**CITY OF CENTRAL POINT
PLANNING COMMISSION AGENDA
June 6, 2017 - 6:00 p.m.**

**SITE PLAN AND ARCHITECTURAL REVIEW APPLICATION FOR SMITH CROSSING
AT TWIN CREEKS**

Consideration of a Site-Plan and Architectural Review application to construct a 245 unit multi-family residential development. The project site consists of two (2) lots located in the Twin Creeks Transit Oriented Development (TOD) Master Plan area within the Medium Mixed Residential (MMR) zone. The 9.51 acre project site fronts North Haskell Street and is identified on the Jackson County Assessor's Map as 37S 2W 03C Tax Lot 138 and 37S 2W 03DC Tax Lot 3400. **Applicant:** Milo Smith; **Agent:** Scott Sinner.

Exhibit 3, Circulation Plan

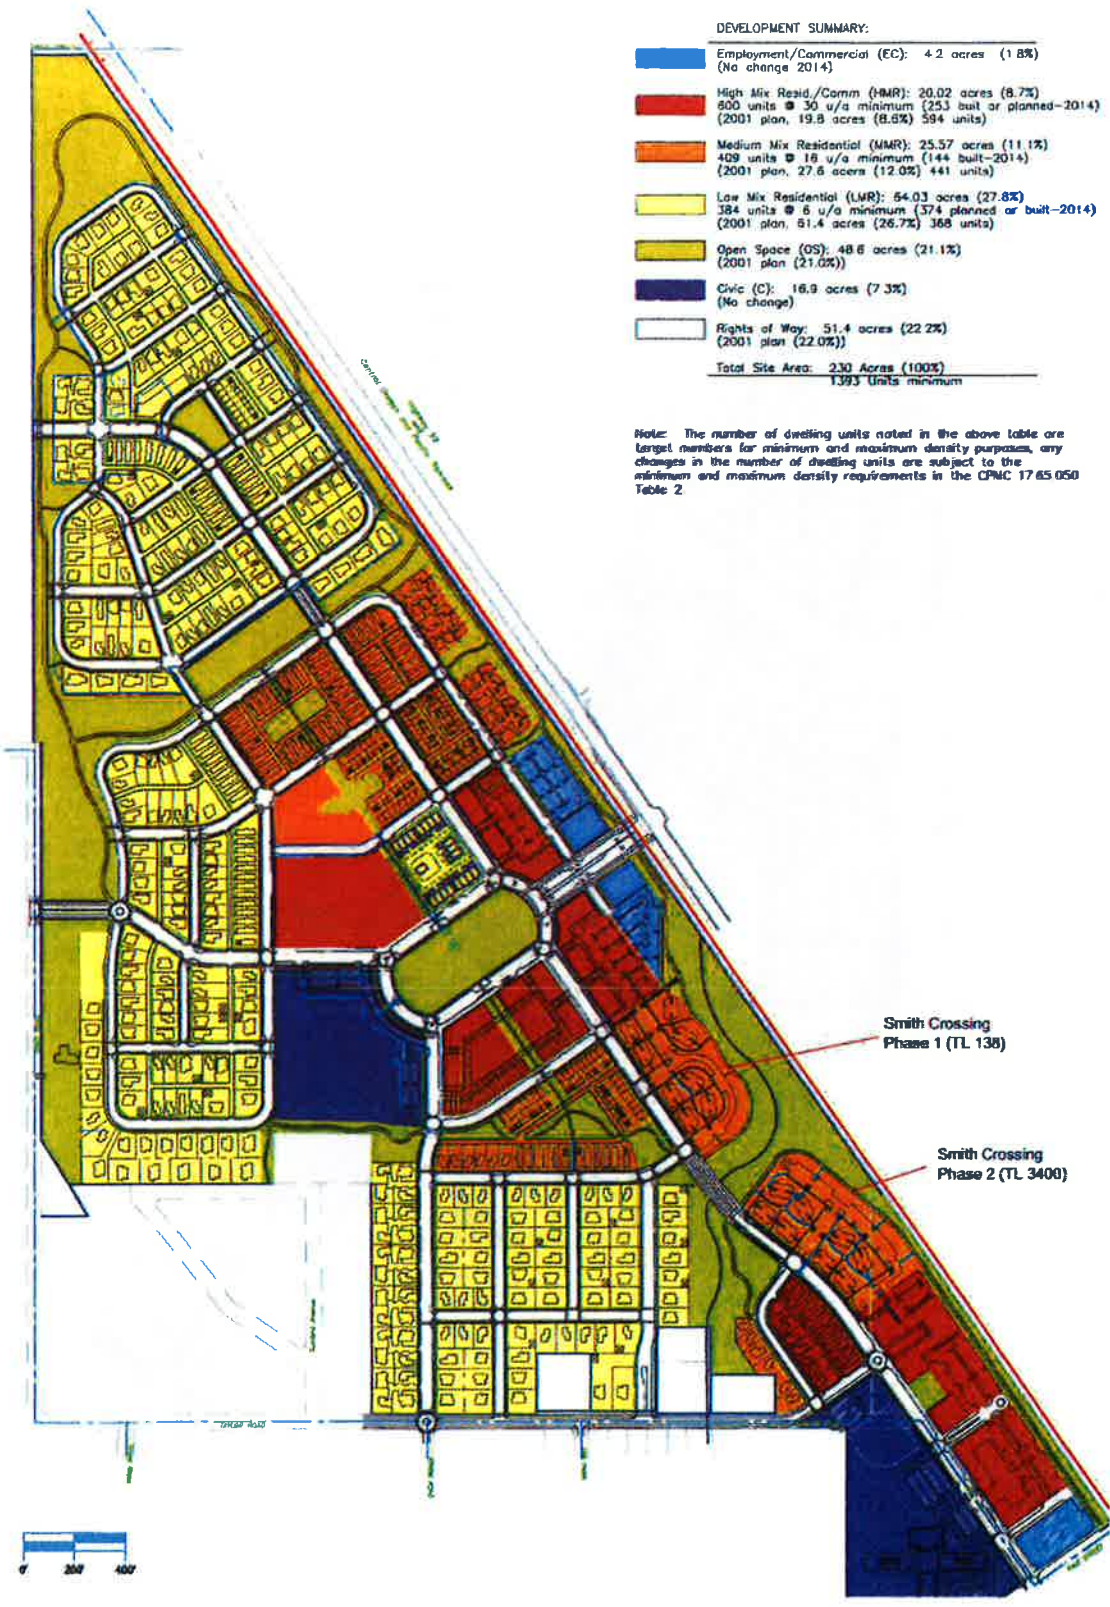
1. **Master Plan.** The Twin Creeks Master Plan governs land use and circulation. A review of the proposed site development in the context of the Master Plan requires clarification of shared access and traffic impacts as follows:
 - a. **Shared Access.** Phase 1 provides a private drive connection with the adjoining property to the northeast (TL 1500), which is illustrated in the Master Plan Exhibit 3, Circulation Detail (Attachment "G"). The Applicant is requesting that the shared connection be for emergency vehicle use only through placement of a fire access gate or similar apparatus. Per the Applicant's findings, the basis of the request is to avoid potential safety conflicts of off-site commercial traffic generated by a future land use on Tax Lot 1500.

4. **Minor Pedestrian Accessway.** Phase 1 proposes a minor pedestrian accessway required per Master Plan, Exhibit 3. There is a 65-ft segment at the northeast property corner that does not provide the required 24" landscape row between the drive and the pathway per the standard identified in Master Plan Exhibit 12 (Attachment "B").

Comment: On January 24, 2017 the Community Development Director approved a senior living and memory care facility on TL 1400 (File No. 16032). At that time the provision for shared open access was shifted to the east to avoid potential conflicts between the residential facility and a future commercial use on TL 1500. The current request reflects similar concerns for resident safety associated with shared open access to accommodate off-site commercial traffic on TL 1500. In consideration of these concerns and written testimony in support of the Applicant's request provided by the property owner of TL 1500 (Attachment "F"), staff recommends the Planning Commission grant the request to provide shared access for emergency vehicles only.

Comment: The Master Plan identifies the pedestrian connection from North Haskell Street to Twin Creeks Crossing, which could be on the project site or the adjacent open space tract owned by Twin Creeks Development Co. To meet the standard pathway cross section, it will be necessary for the Applicant to locate a portion of the pathway on the open space tract. Staff recommends that the Applicant provide written authorization and a revised site plan demonstrating compliance with the Minor Pedestrian Accessway standard per the Master Plan prior to building permit issuance.

1. Prior to building permit issuance for any structure in any Phase, the Applicant shall provide a copy of a signed and recorded reciprocal access easement with the adjoining parcel to the North (37S 2W 03CA Tax Lot 1500 and 37S 2W 03CA Tax Lot 1400) ("Lots") as necessary to allow shared access between the Lots for emergency purposes.

4. Prior to building permit issuance for any building in Phase 1, the Applicant shall provide a written authorization to locate a portion of the Minor Pedestrian Accessway identified in the Twin Creeks Master Plan, Exhibit 3 on the adjacent open space tract, as necessary to comply with the Minor Pedestrian Accessway standard in Master Plan Exhibit 12.

PHASE 1

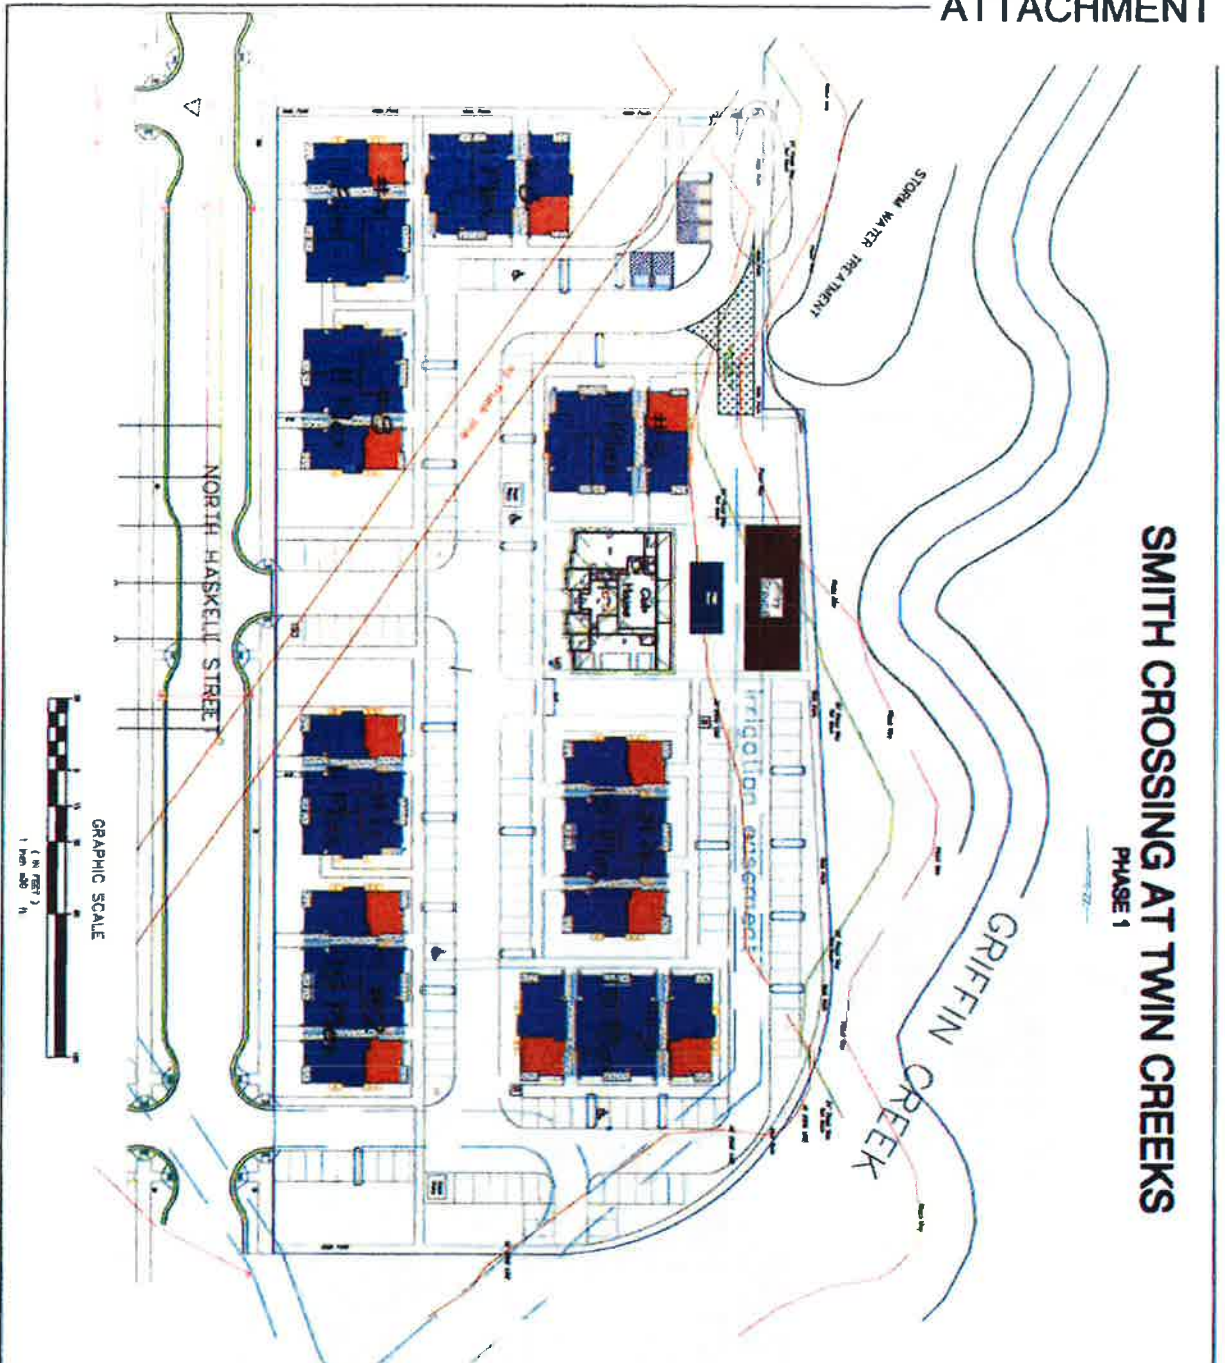
2. **Special Flood Hazard Area (SFHA).** A small portion of Phase 1 is within the SFHA (Attachment "C-1") Most of the impacted area is planned for parking and landscape improvements but utilities for Building 5 are shown within the SFHA.

Comment: Floodplain development proposals are subject to compliance with CPMC 8.24, Flood Damage Prevention. There are no requirements relative to the proposed landscape and parking improvements; however, Building No. 5 will be subject to the residential construction standards for development in high risk floodplains. Compliance verification is a function of the building permit process. Staff recommends a condition that the Applicant obtain a floodplain development permit for Building No. 5 prior to building permit issuance unless it can be demonstrated through a Letter of Map Amendment (LOMA) that the building site is located above the 100-year flood elevation (Condition No. 3).

3. Prior to building permit issuance for Building No. 5 in Phase 1, the Applicant shall either 1) provide a Letter of Map Amendment (LOMA) from the Federal Emergency Management Agency (FEMA) demonstrating that the site for Building No. 5 is outside Flood Zone AE; or, 2) obtain a floodplain development permit for Building No. 5 in Phase 1 as necessary to comply with CPMC 8.24, Flood Damage Prevention requirements for residential construction.

LANDSCAPE PLAN
Scale: 1" = 30'

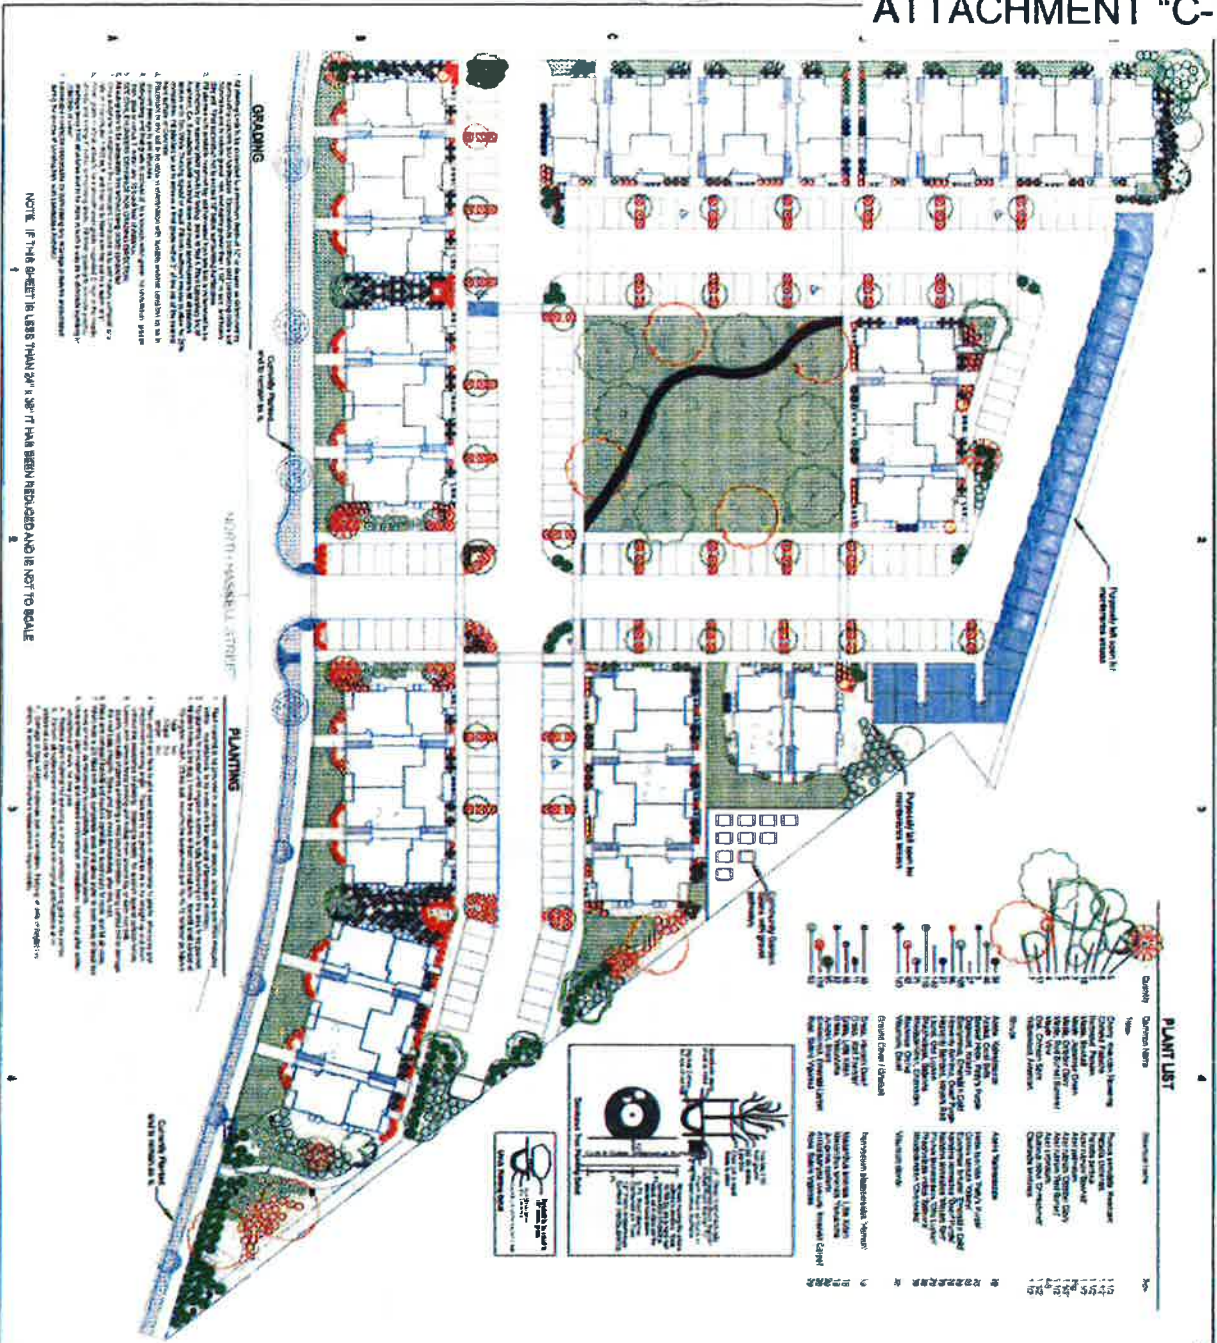
5. **Landscaping.** The Applicant's Landscape Plan (Attachments "C-12" and "C-13") does not provide adequate tree placement at the north entrance to Phase 1 as required in CPMC 17.67.050(K)(2)(a). This section of the code requires tree placement at 30-ft on center. Phases 1 and 2 do not provide adequate screening at the parking lot driveway entrances from North Haskell Street. CPMC 17.67.050(K)(2)(b) requires screening evergreen hedges or decorative fences walls or transparent screens.

Comment: There is sufficient area on the site to accommodate the required landscaping and screening per CPMC 17.67.050(K)(2)(a-b). Staff recommends that the Planning Commission impose Condition No. 5 to require submittal of a revised landscape plan at the time of building permit issuance.

5. At the time of building permit issuance, the Applicant shall submit a revised landscape plan demonstrating compliance with the tree planting and parking lot screening requirements in CPMC 17.67.050(K)(2)(a-b).

Exhibit 3, Circulation Plan Detail

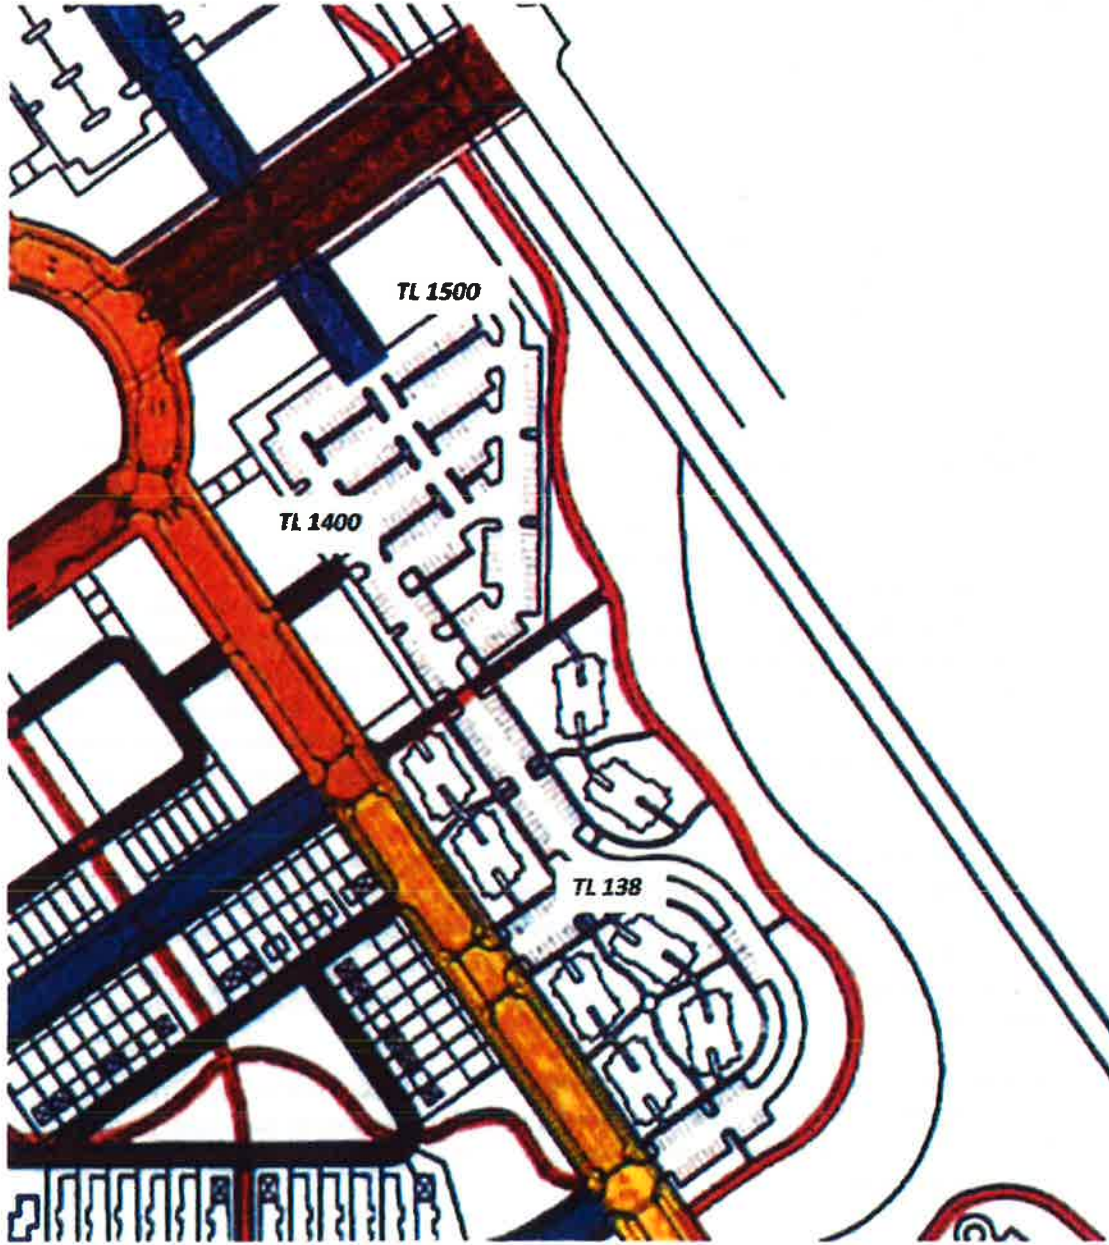
The purpose of this letter is to request a clarification of the Twin Creeks TOD Master Plan relative to Exhibit 3, Circulation Plan specifically for the following properties:

We would like shared access to be limited to use by emergency vehicles between these lots, which will be controlled by a fire access gate or other similar device. The basis of this request is that the Master Plan does not articulate a clear requirement for private shared access other than to illustrate a conceptual connection in Exhibit 3. If required to allow unlimited shared access, there are concerns that commercial traffic generated by a future land use on Tax Lot 1500 would be incompatible with and cause a safety hazard to future residents of the medium residential multifamily development on Tax Lot 138. By limiting access to emergency vehicles only, concerns about resident safety will be addressed.
